Planning Report

Noah's Events Venue

15-036INF
Informal Review
Noah's Event Venue
Perimeter Drive

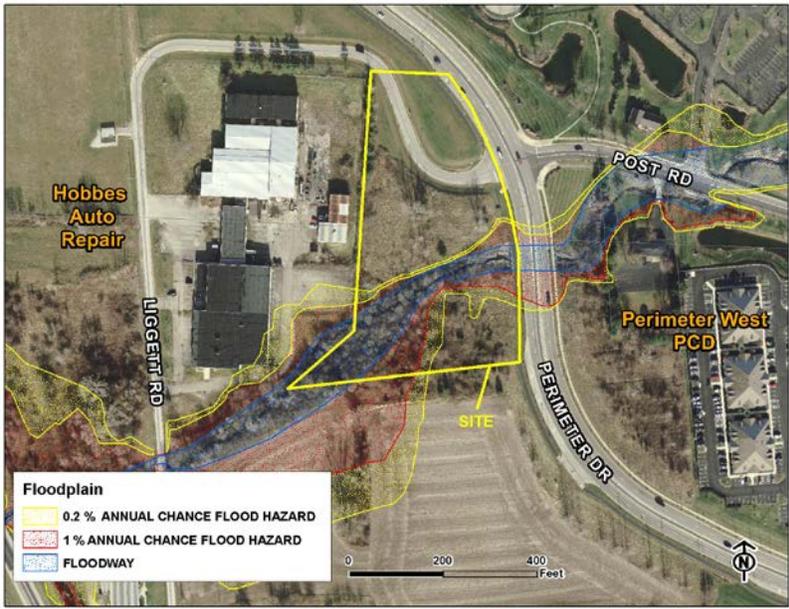
Layout	Access is shown off Ligget Road in the northwestern portion of the site, with parking spaces proposed immediately off this access drive along the western site boundary. No access is proposed off Perimeter Drive. The building is proposed in the very southern portion of the site, south off the stream and the 144-space parking lot is north of the stream. A walk is proposed surrounding the west, south and east boundary of the parking

Details	Informal
	<p>lot connecting to an existing shared-use path on the west side of Perimeter Drive. The parking lot provides access to the building by a walking path that crosses the floodplain. The parking area and building are primarily located outside the boundaries of the floodplain but the walking path cross the floodway and the floodway fringe. The proposal includes a walking path and bridge over the stream to provide access from the parking lot to the building. A path is also proposed around all sides of the building. The plans include outdoor amenity areas on the east and west sides of the building.</p> <p>The proposal will require tree removal given the proposed site constraints in terms of flood plain and permitted building location. However, no amenity details are included at this stage of the proposal.</p> <p>The plans do not appear to accurately reflect building and pavement setbacks. Code requires a building setback along Perimeter Drive of 50 feet and the required parking setback is 30 feet. The applicant should relocate the dumpster from the Perimeter Drive frontage if this application moves forward.</p>

Parking	<p>The proposal includes 144 parking spaces. For a medical office use of 8,700 square feet, the required parking would be 44 spaces. The applicant has not included information demonstrating their anticipated parking needs or provided information on typical attendance numbers at corporate events or social functions. The proposed parking ratio is one space per every 60 square feet.</p>
Architecture	<p>The proposed architecture shows a flat-roofed building, approximately 23 feet in height with brick as the primary building material. The building base is cast stone and tile is used as an accent material. A cast stone cap and accents are also proposed. Each elevation incorporates large windows and wood trellises above doors are proposed.</p>
